# ADDENDUM No. 1

## RFP No. 23-59

### East Medical Center Drive Bridge Rehabilitation and Widening Project

PROJECT MANAGEMENT - PUBLIC SERVICES - CITY OF ANN ARBOR	
E. MEDICAL CENTER DRIVE TRAFFIC SIGNAL PLANS FULLER RD AT E. MED. CENTER RD STAGE 1	
SCALE 1"=20'	INCH 0 1
DRAWING NO. 2021-008-MOT34	
SHEET NO. 38 OF 155

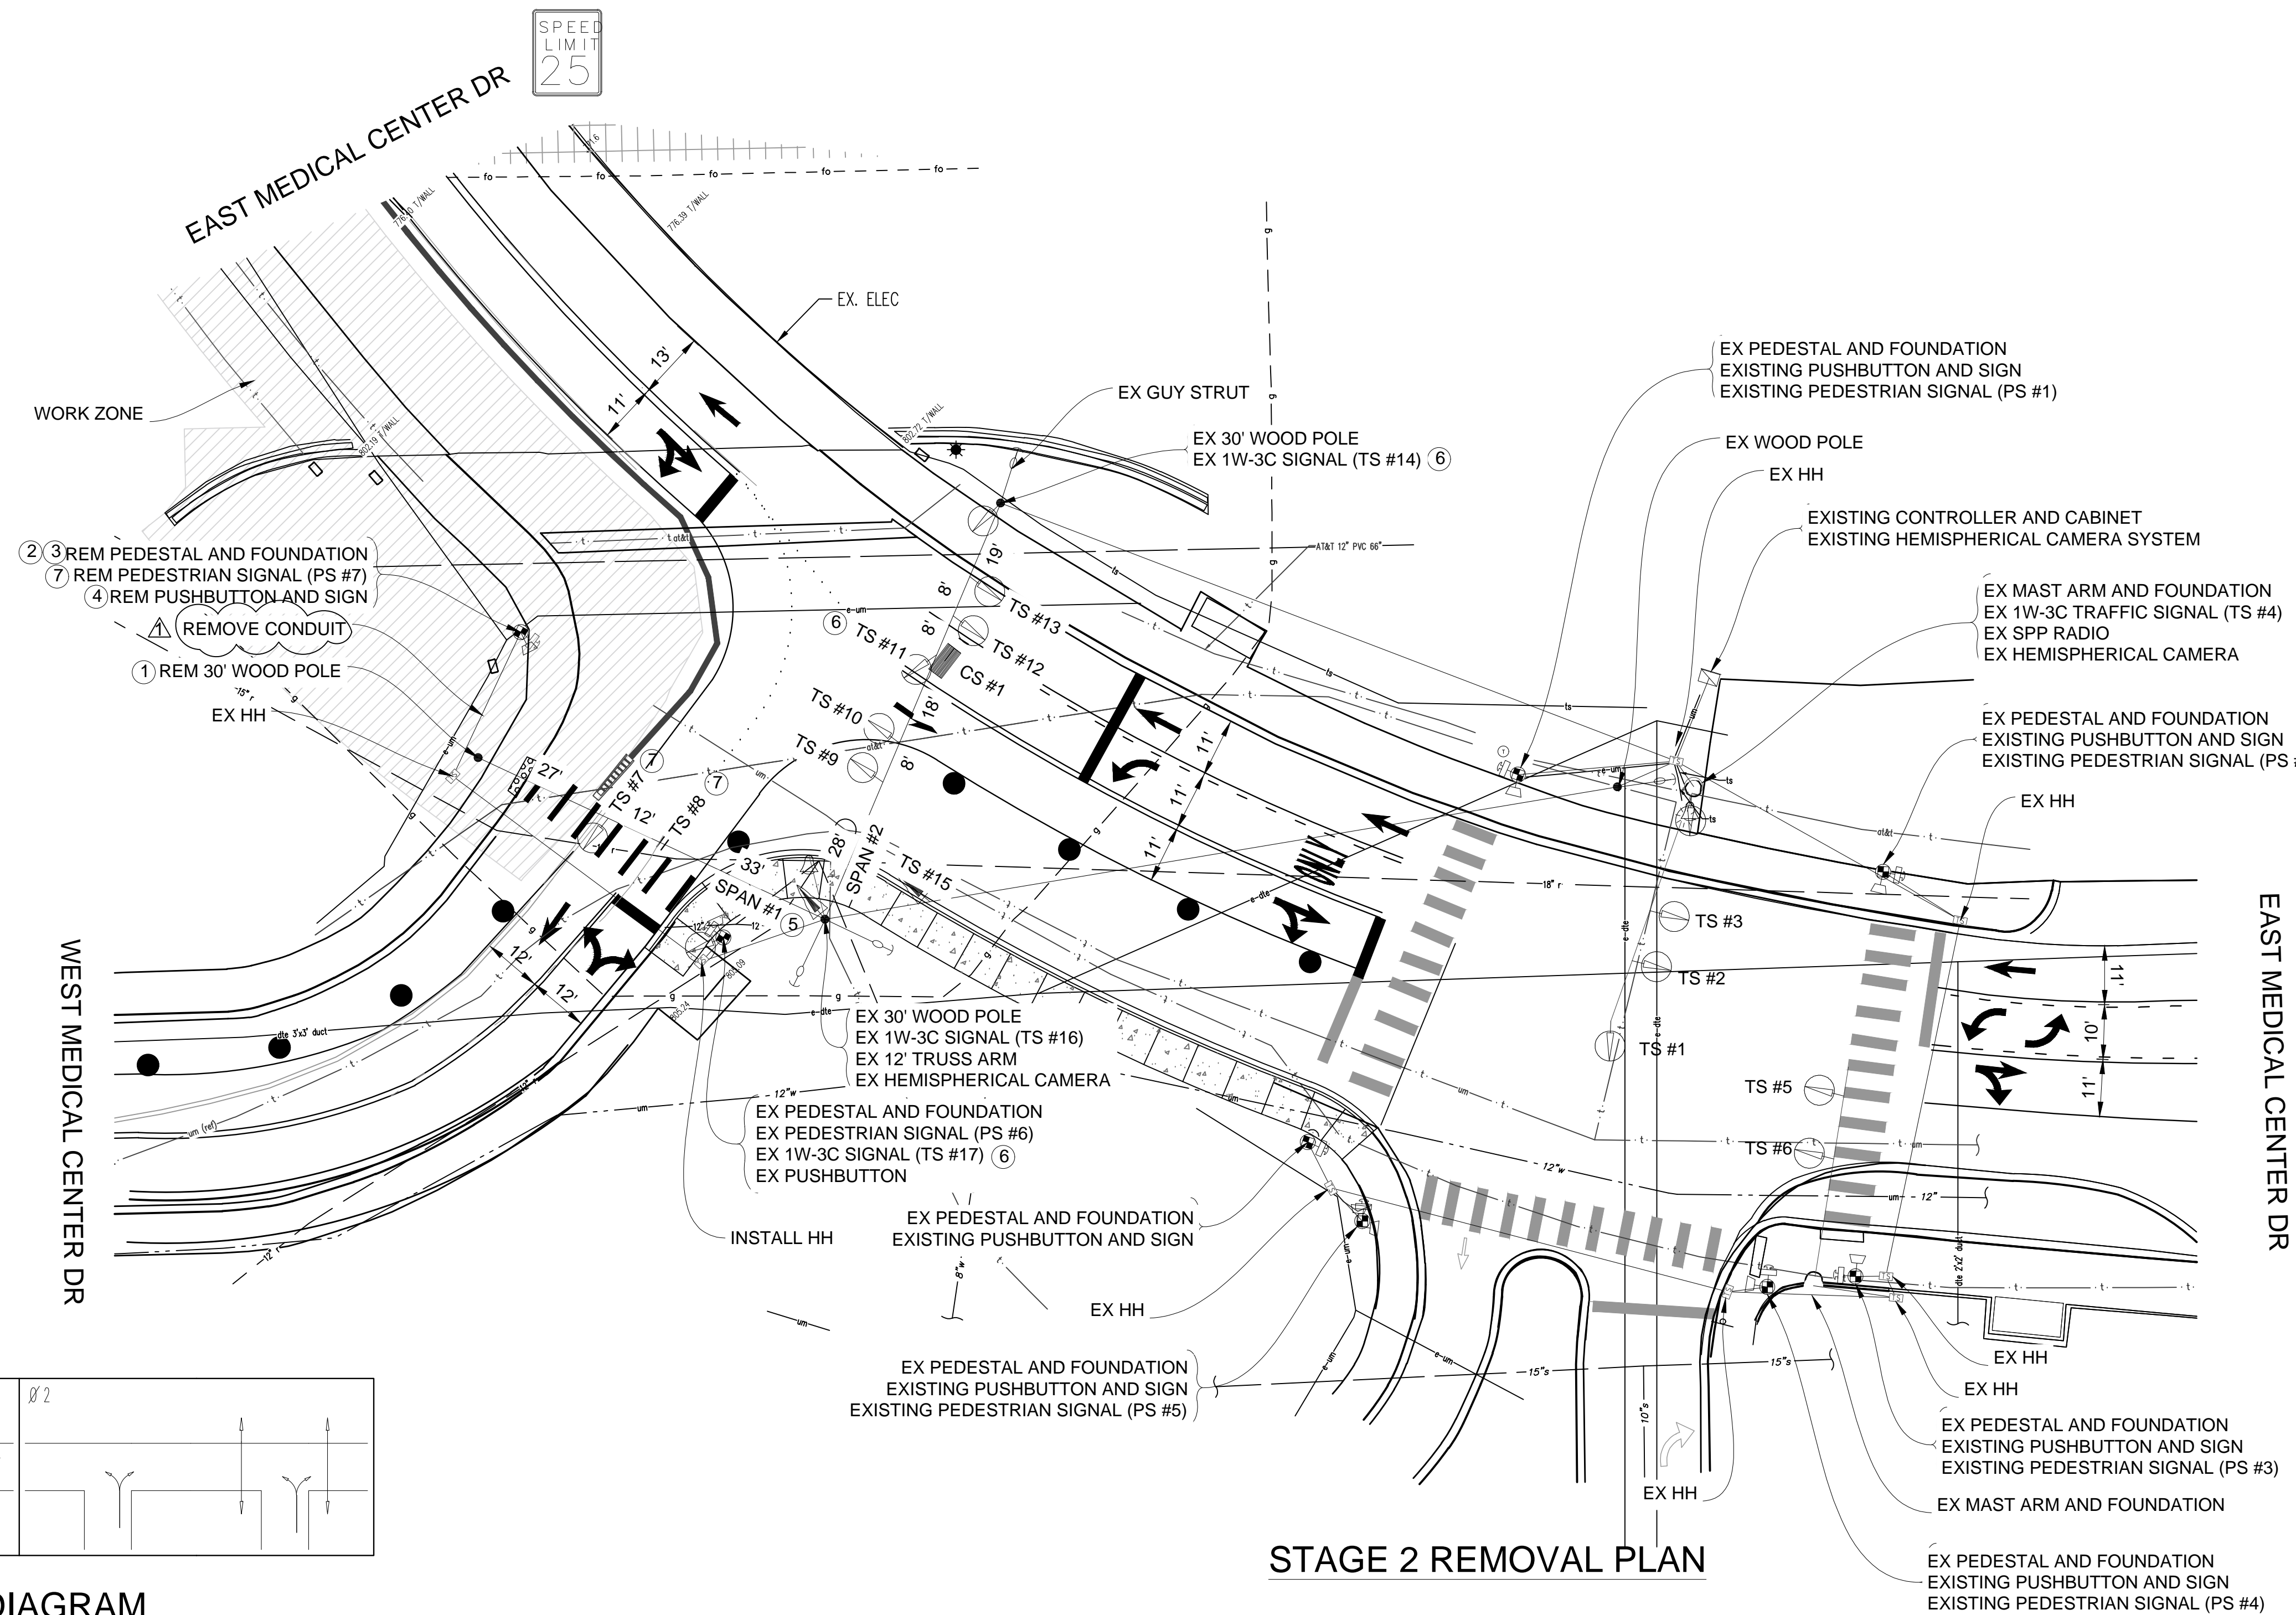
- Question 15: One pedestrian traffic signal is called out to be removed for the widening in 2021-008-MOT34, and a completely new pedestrian traffic signal is called out to be reinstalled on 2021-008-MOT36. Is the intention to install a completely assembly or to relocate the existing ped signal components (Metal Base, Post, Pushbutton, Ped Signal etc...)? Please clarify.

- Answer 15: The items being removed are the pedestal, foundation, and pushbutton. No pedestrian signal is present on the pedestal. Original installation date is unknown so age couldn't be verified. New equipment was proposed due to this.

PROJECT MANAGEMENT - PUBLIC SERVICES - CITY OF ANN ARBOR			
E. MEDICAL CENTER DRIVE TRAFFIC SIGNAL PLANS FULLER RD AT E. MED. CENTER RD STAGE 2			
SCALE	1"=20'	INCH	
DRAWING NO.	2022-008-MOT38		
SHEET NO.	42 OF 155

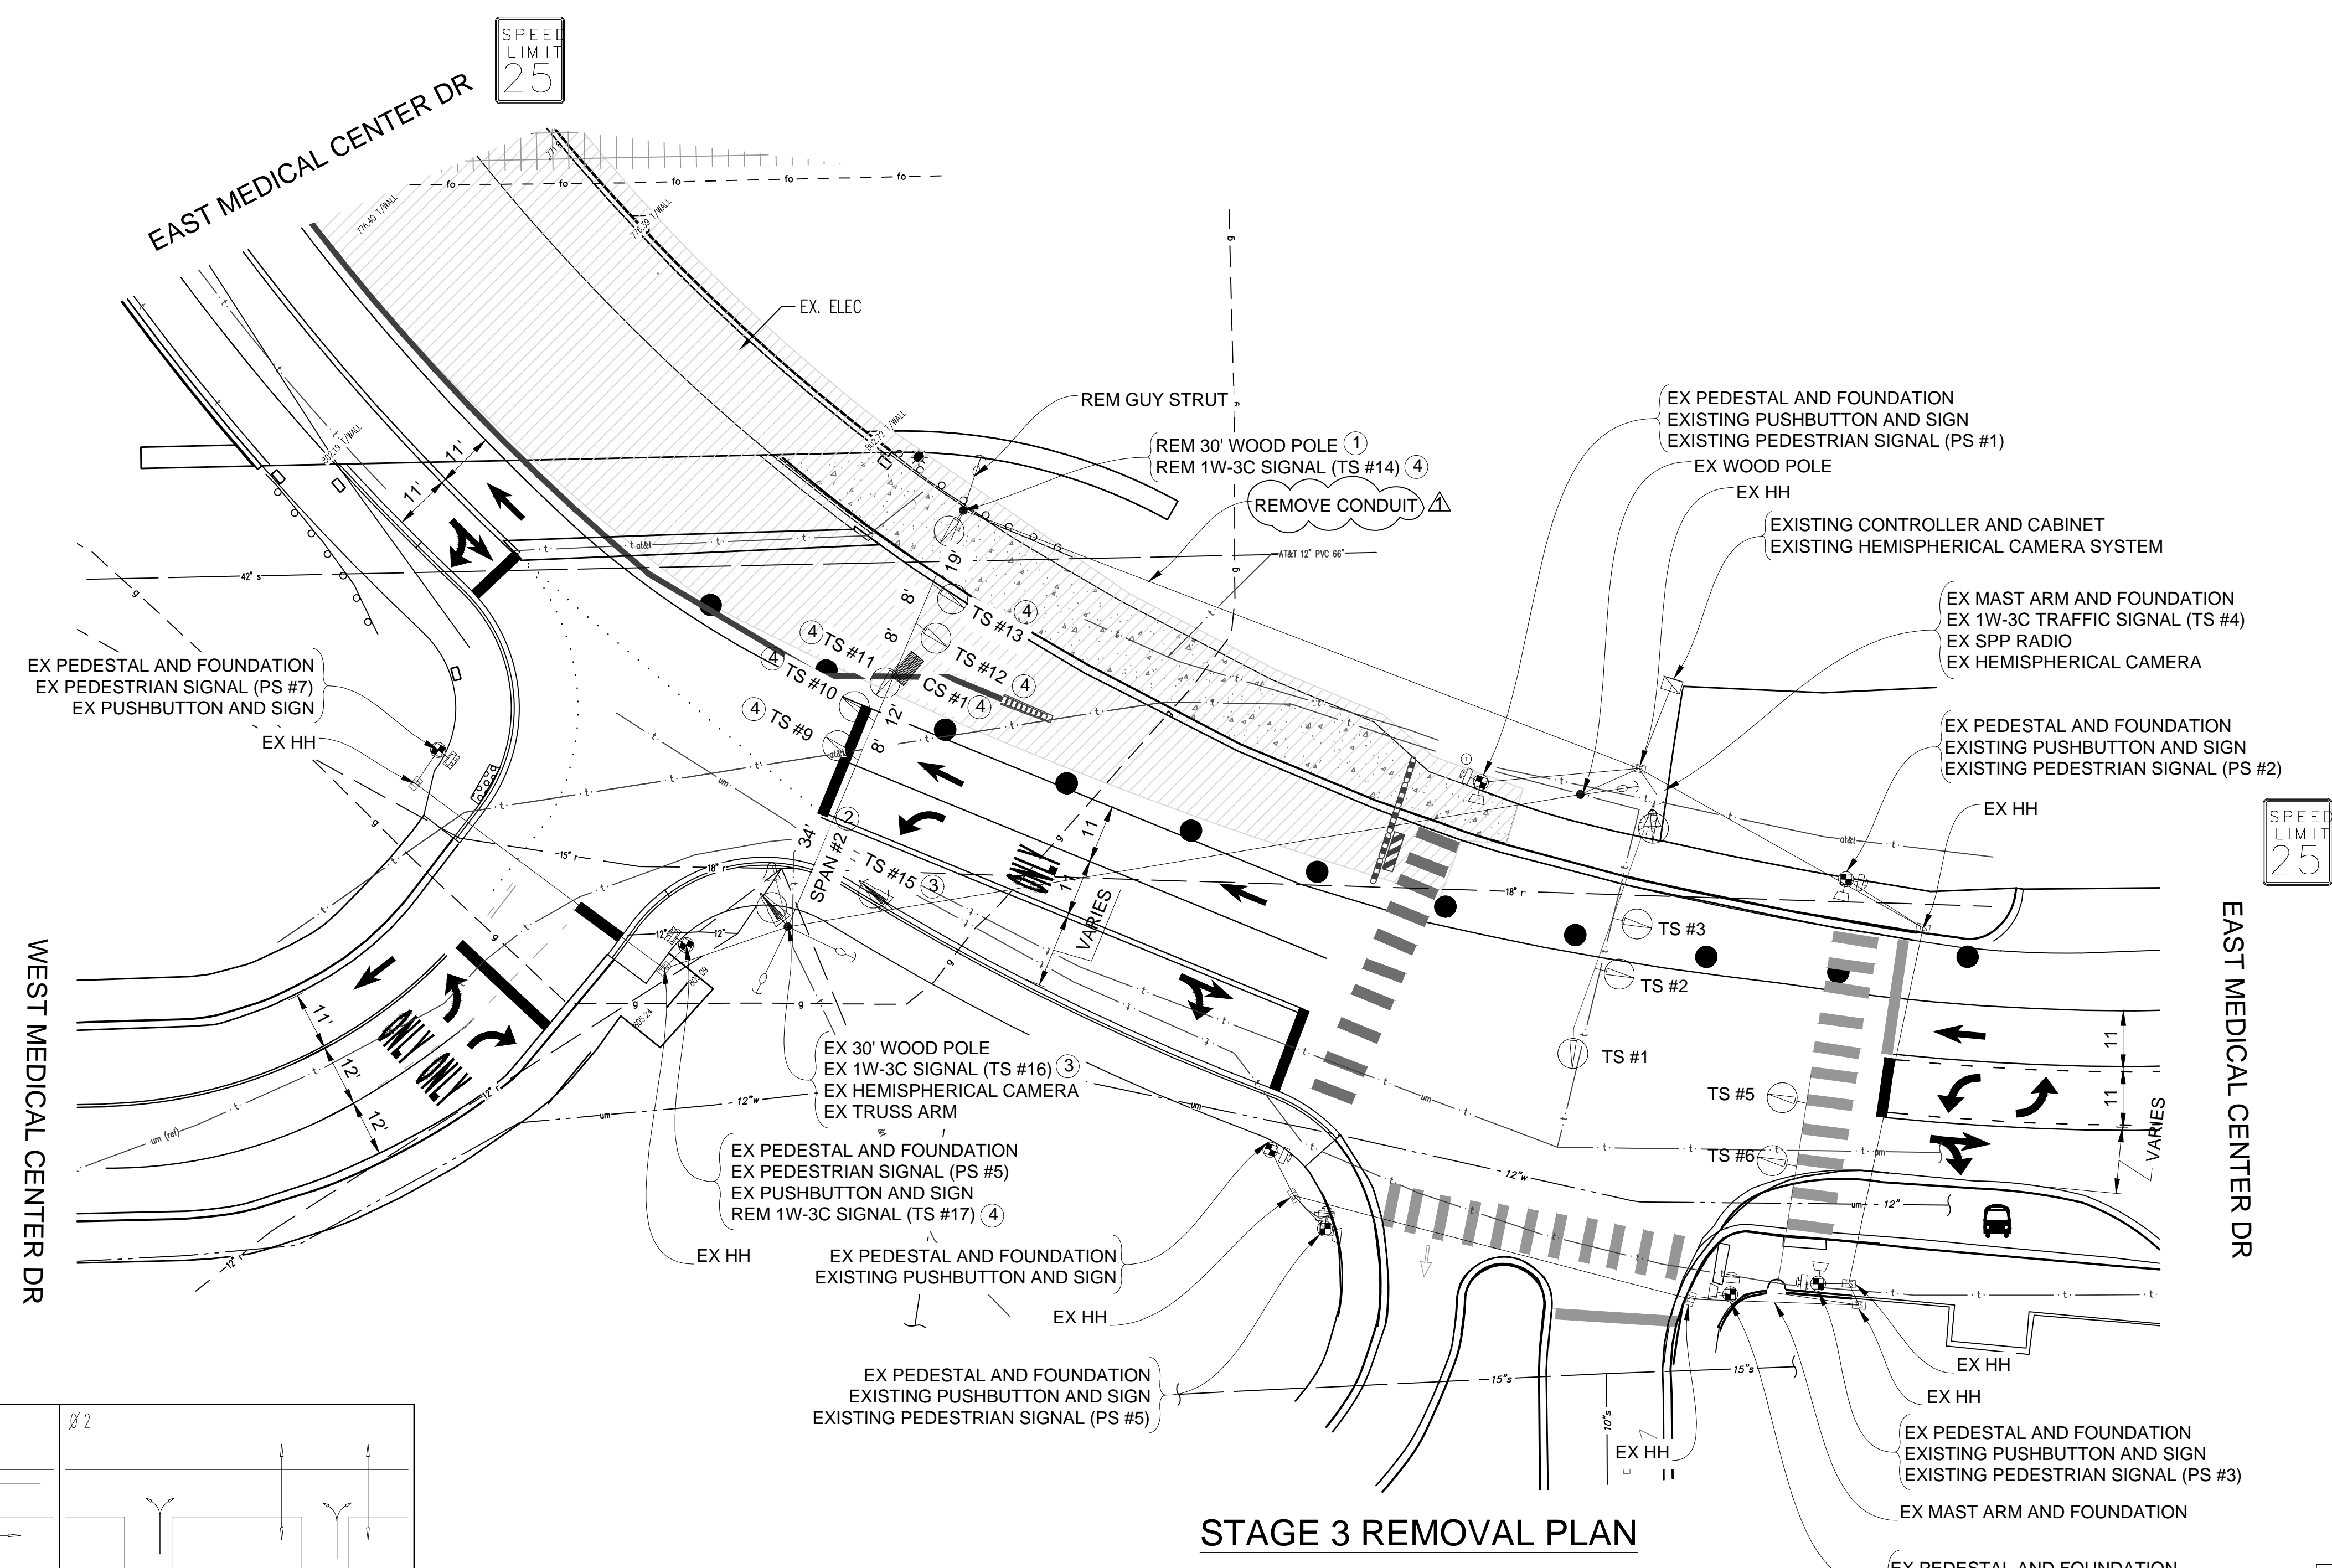
- Question 13: Conduit removal is shown in the qty T/O table but not specifically called out on plan. This applies to the following drawings:  
2021-008-MOT34  
2022-008-MOT38  
2021-008-MOT40  
2022-008-MOT42  
2022-008-MOT46  
Please Clarify

- Answer 13: The plan sheets have been updated with callouts for the conduit removals.
- Question 14: Traffic signal plans exist for Fuller Rd at E Med Center Rd for Stage 1, 2,4 and final removal (2021-008-MOT24 Thru 2021-008-MOT32. There are no plans provided for Stage 3. Please provide stage 3 plans.

PROJECT MANAGEMENT - PUBLIC SERVICES - CITY OF ANN ARBOR	
E. MEDICAL CENTER DRIVE TRAFFIC SIGNAL PLANS FULLER RD AT E. MED. CENTER RD STAGE 3	
SCALE 1"=20'	INCH 0 1
DRAWING NO. 2022-008-MOT42	SHEET NO. 46 OF 155

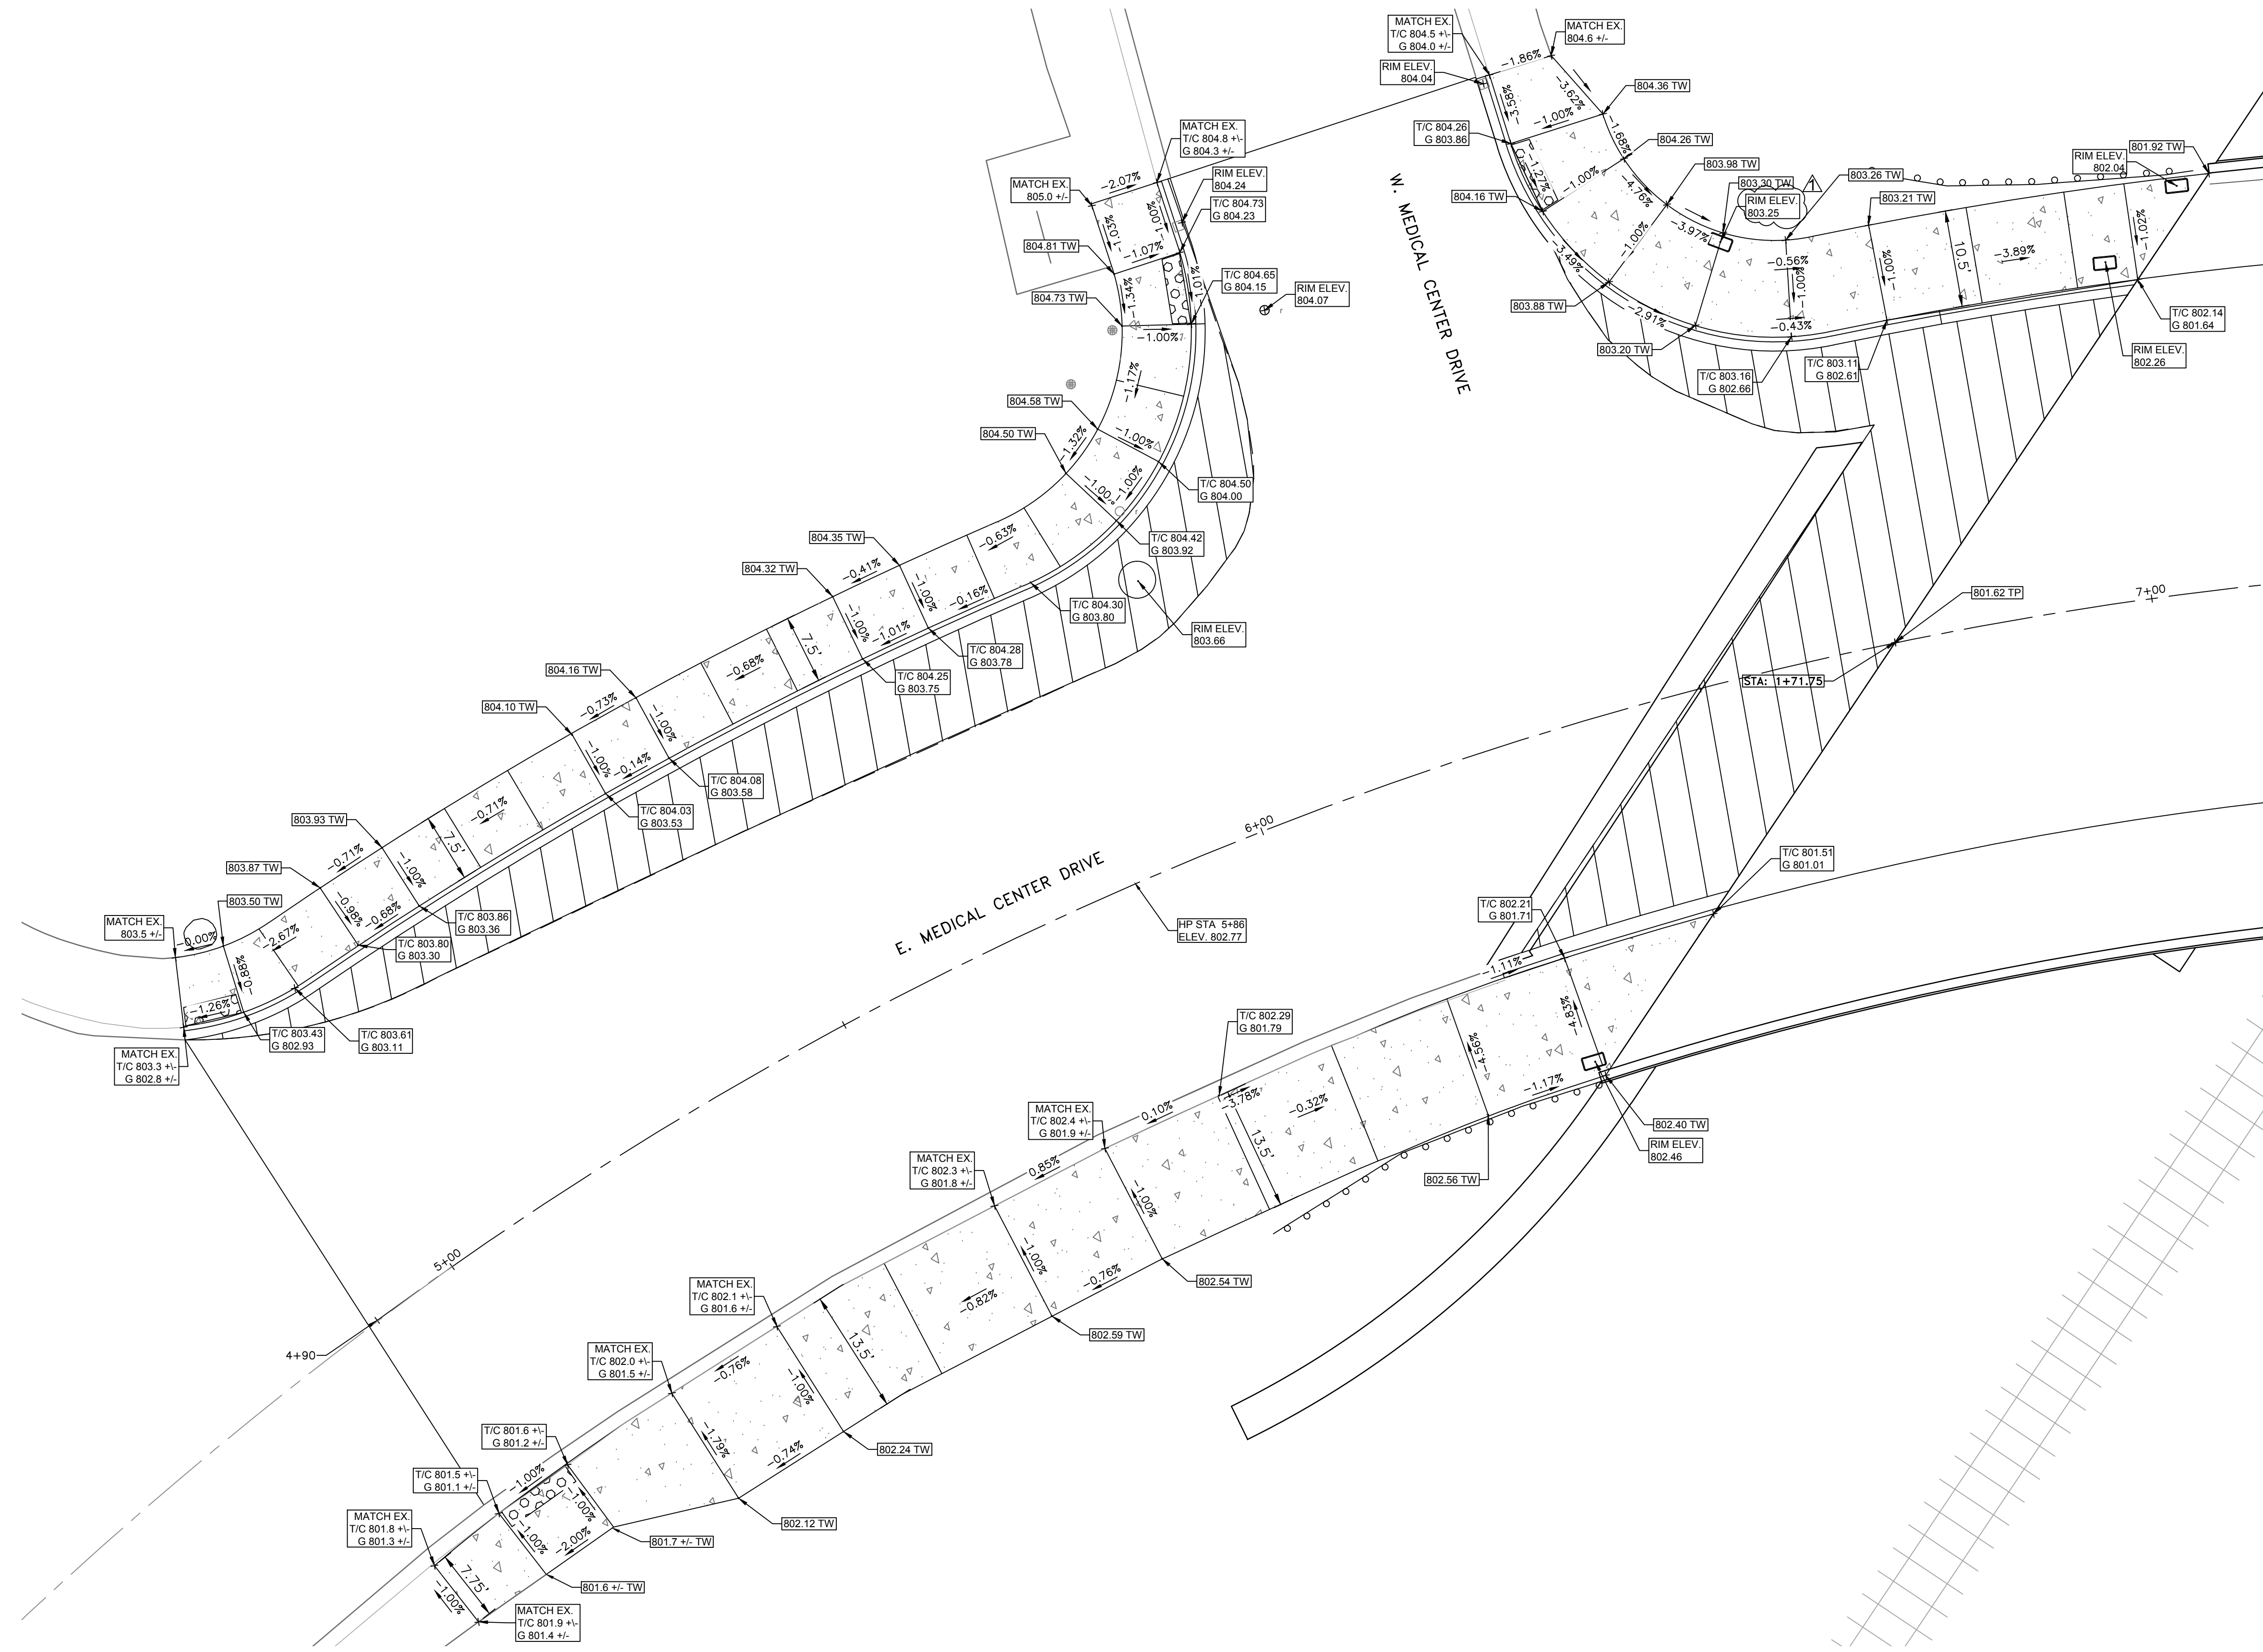
Question 27: Drawing 2021-008-MOT46 indicates that 80 LF of conduit is to be removed. Please confirm if the previously installed 1.5" directionally bored conduit routed under W med drive is intended to be removed completely or abandoned in place.

Answer 27: The previously installed 1.5" directionally bored conduit shall be abandoned in place.
